## DS-K5671 Series MinMoe Terminal Release Notes (2021-09-09)

<b>Device Model:</b> DS-K5671-ZV/ZH/ZU	Firmware Version	ARM: ACS_671_AI3_EN_STD_V3.2.0_build210731 ACS_671_AI3_EN_NEU_V3.2.0_build210731
	SDK	Latest version
	iVMS-4200 Version	Latest baseline

# DS-K5671 Series MinMoe Terminal Release Notes (2021-06-28)

# DS-K5671 Series MinMoe Terminal Release Notes (2021-02-08)

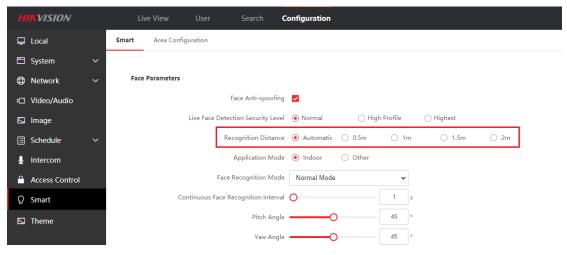
1. Add Hik-Connect menu in device UI Menu→Comm. The function is disabled in default.

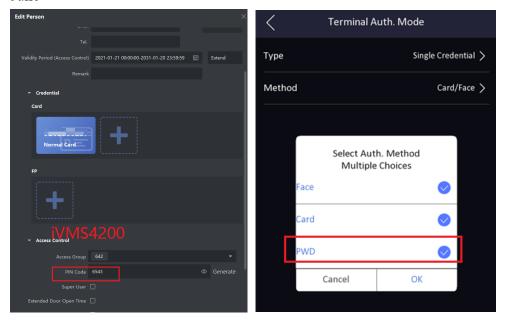
7. Support PIN code to open the door (disabled in default)

Note: PIN code should be configured from software, iVMS4200 already support, HikCentral Pro will support PIN code configuration in V2.1 expected to be released in June

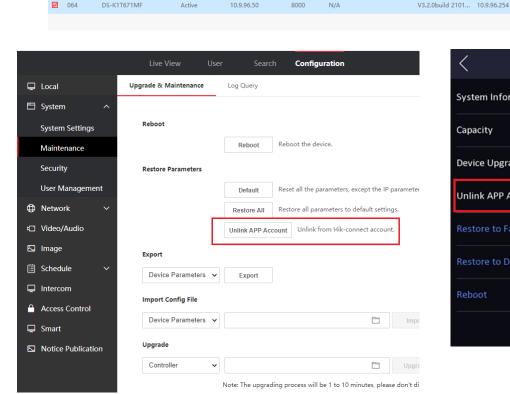
8. Support unbind device with hik-connect account on SADP tool, local UI and web interface

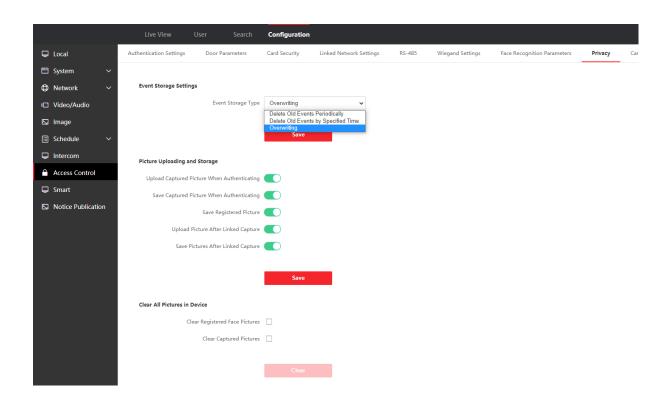
11. Add privacy protection, customer can define the privacy related parameter, such as Event Storage Settings, Picture Uploading and Storage, Clear All Pictures in Device

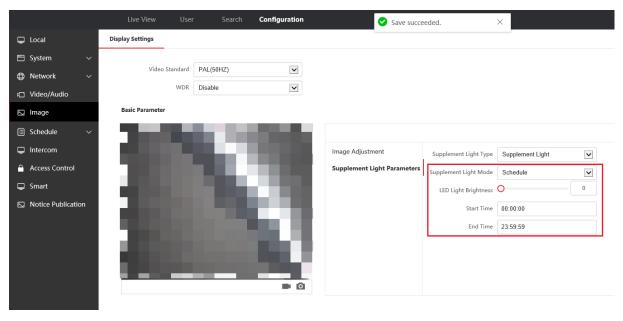
12. Configure the time period when the white light fill light is turned on and off in device local menu or web interface

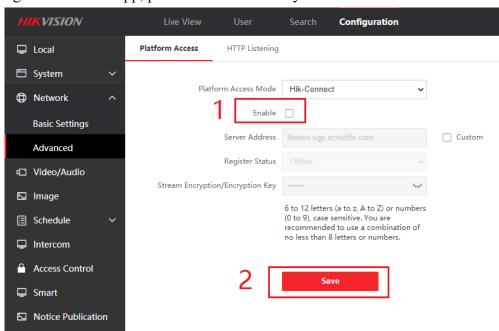
3. Hik-Connect function is turned off in default for privacy protection, if customer want to manage device from App, please turn on manually in the web.

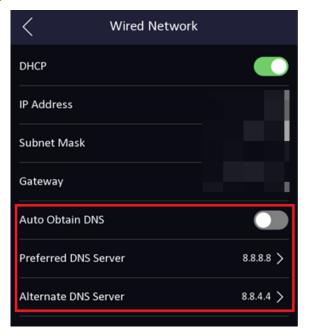
- 4. The face matching algorithm is upgraded. Improve the speed and accuracy of face recognition. Improved the recognition effect of dark masks
- 5. DNS can be configured from device UI in menu→Comm.-->Wired Network

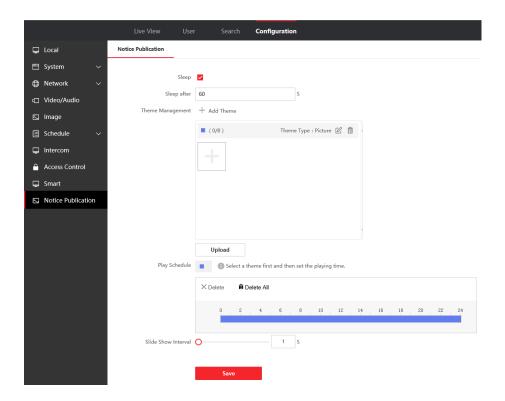
8. Add advertisement/wallpaper play schedule configuration, slide show interval.
